South Texas Project Electric Generating Station P.O. Box 289 Wadsworth, Texas 77483

November 22, 2010  
U7-C-STP-NRC-100241

South Texas Project  
Units 3 and 4  
Docket Nos. 52-012 and 52-013  
Response to Request for Additional Information

Figure 2.4S.5-9 PMH used in conjunction with ADCIRC model

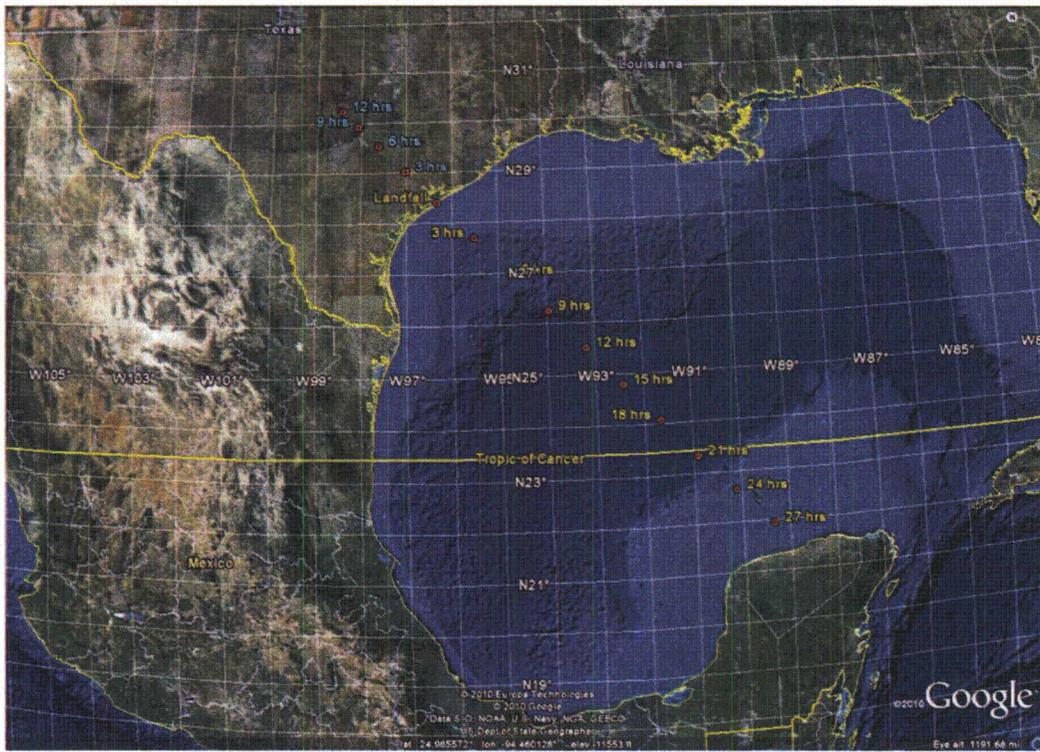
STPNOC will revise the Part 2, Tier 2, Section 2.4S.5.2 of the COLA to include a description of the ADCIRC model and the PMSS prediction based on the ADCIRC model:
